RE: City of Duluth Bid #11-4403
(New Passenger Terminal Bid Package 2B)

Addendum No. 2

**NEW PASSENGER TERMINAL
DULUTH INTERNATIONAL AIRPORT
DULUTH, MN**

A401

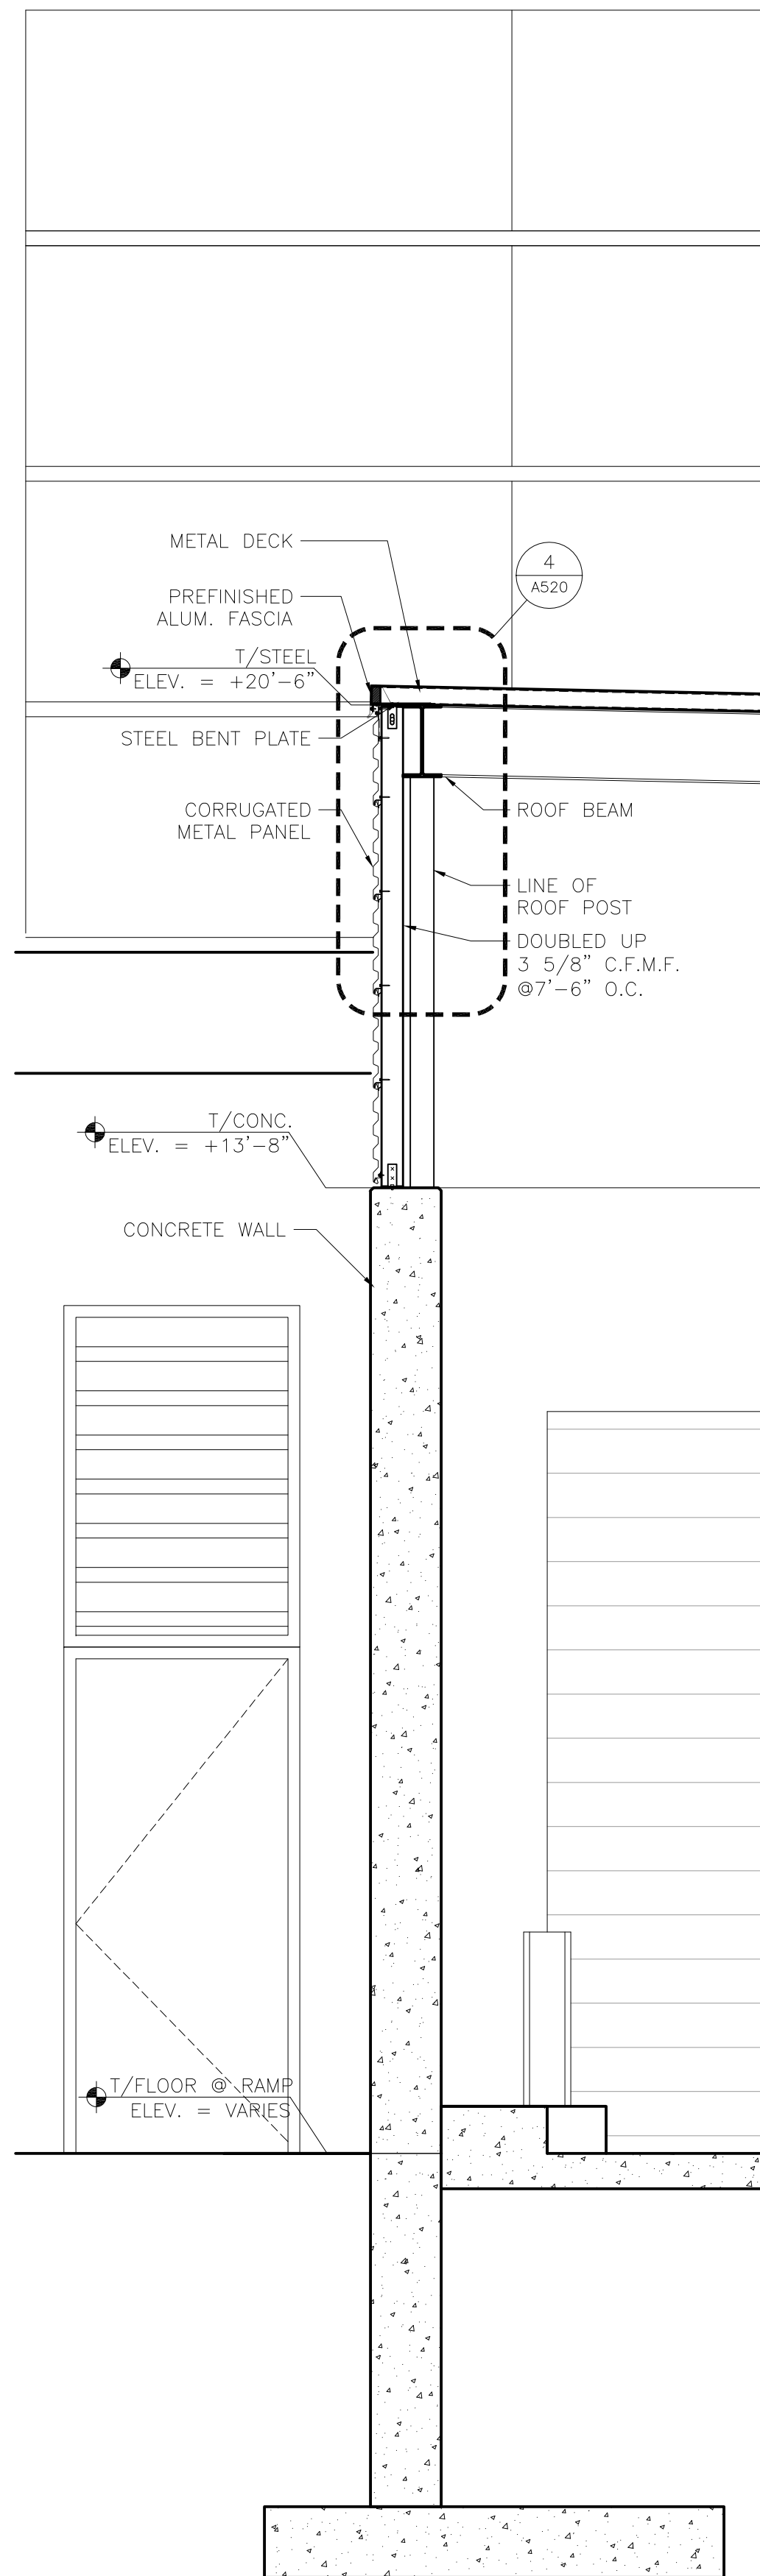
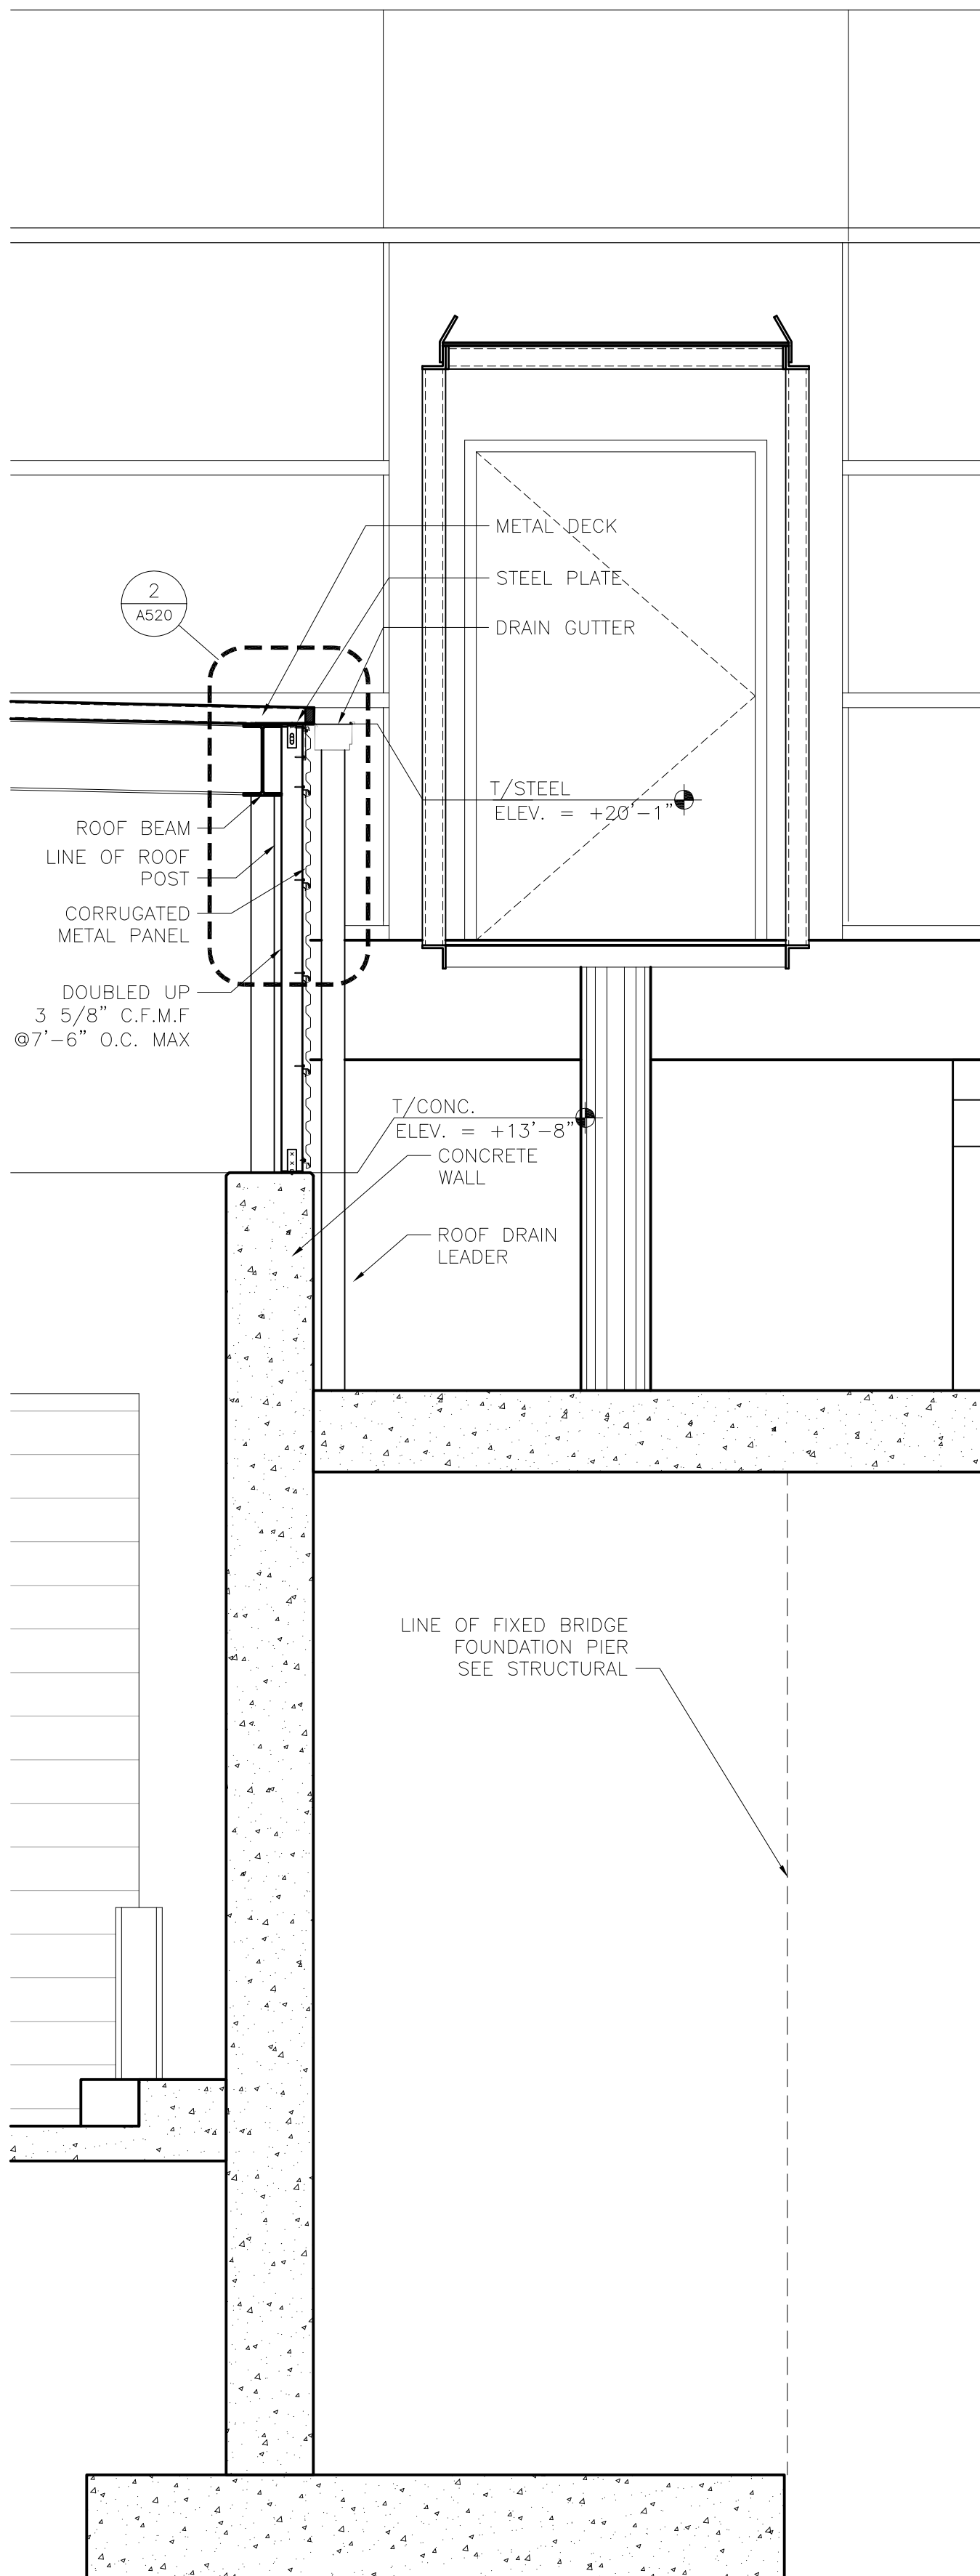
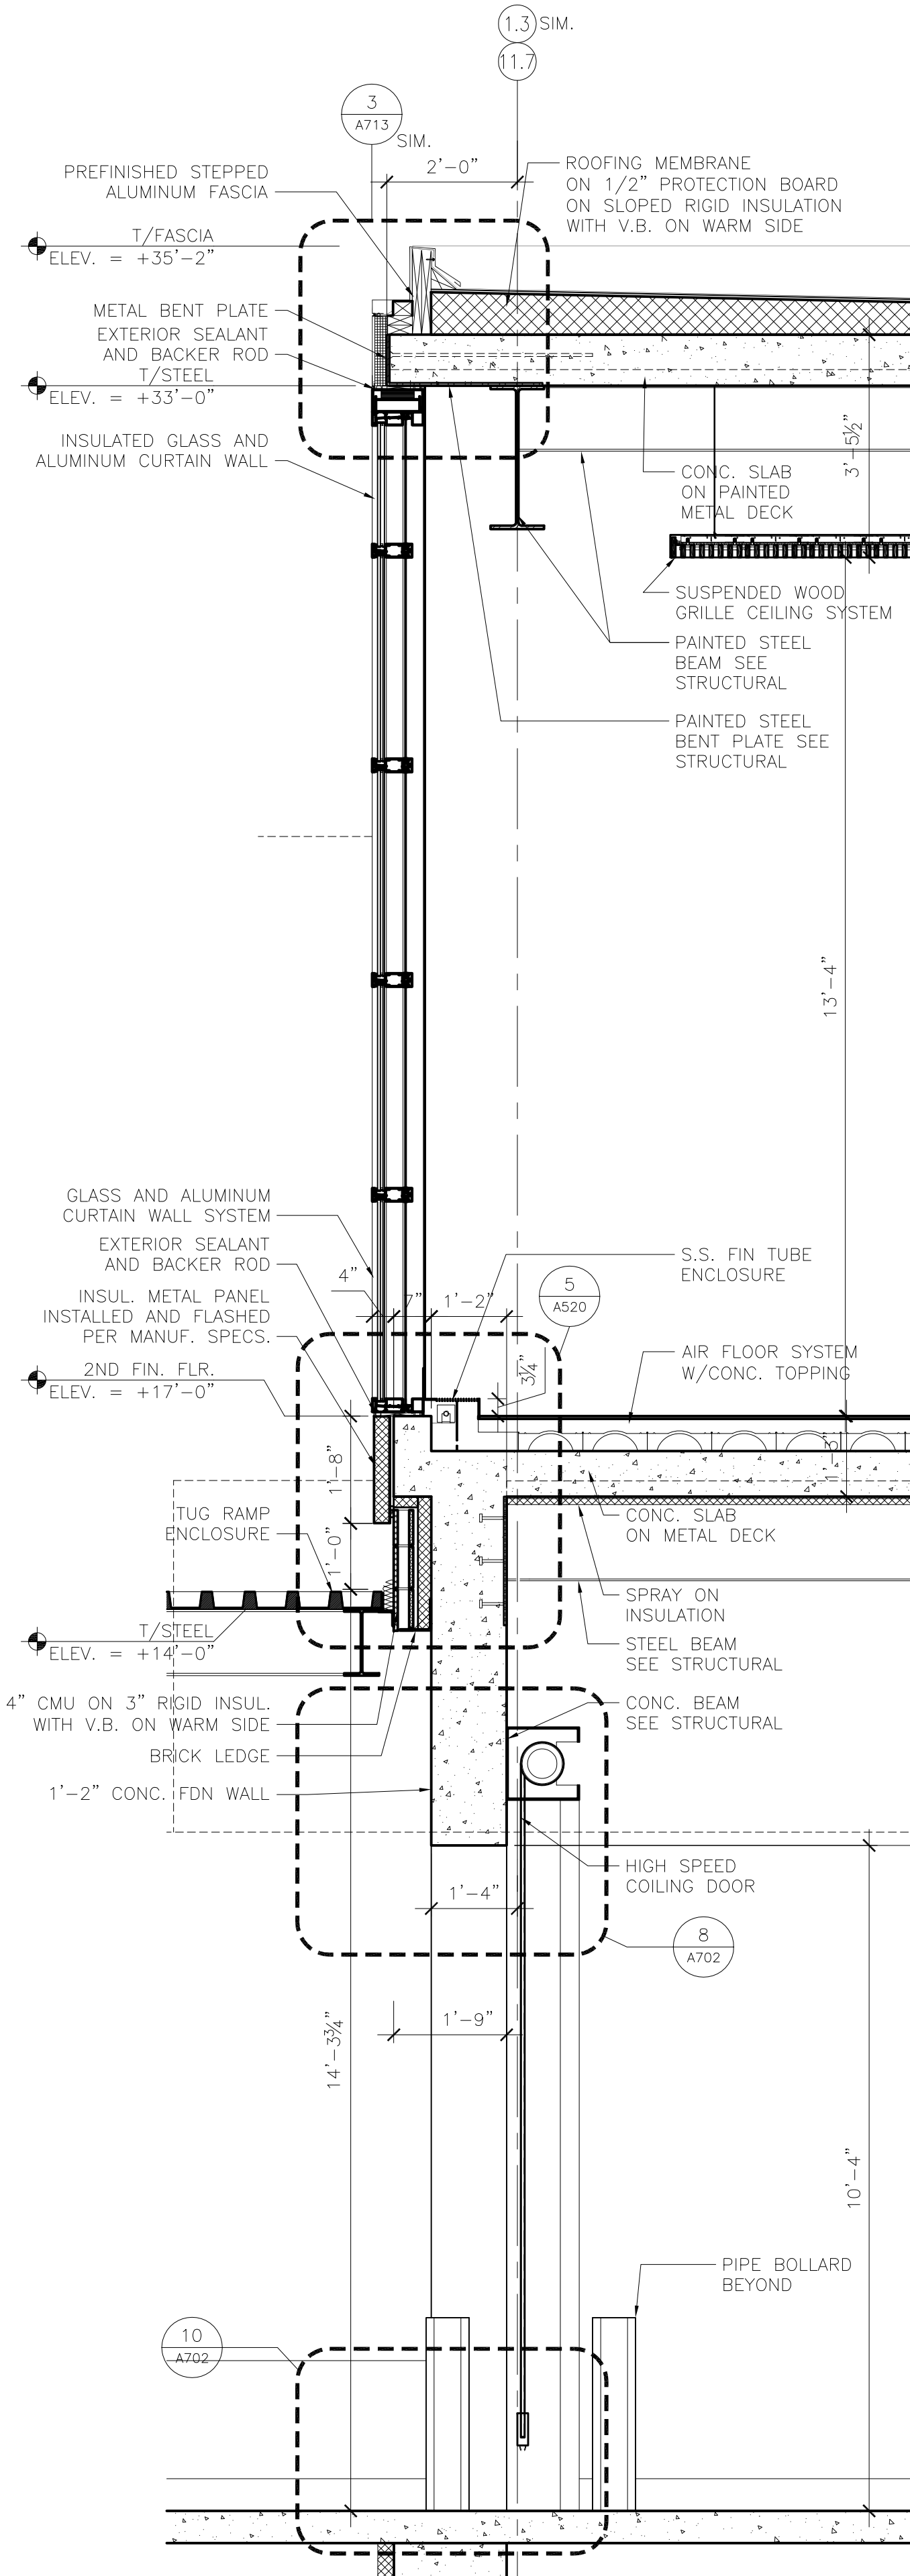
- Sheet A215: Added dimensions for gypsum board ceilings.
- Sheet A401: Revised gypsum board ceiling in Detail 1.
- Sheet A510: Revised corner guards in Detail 8.
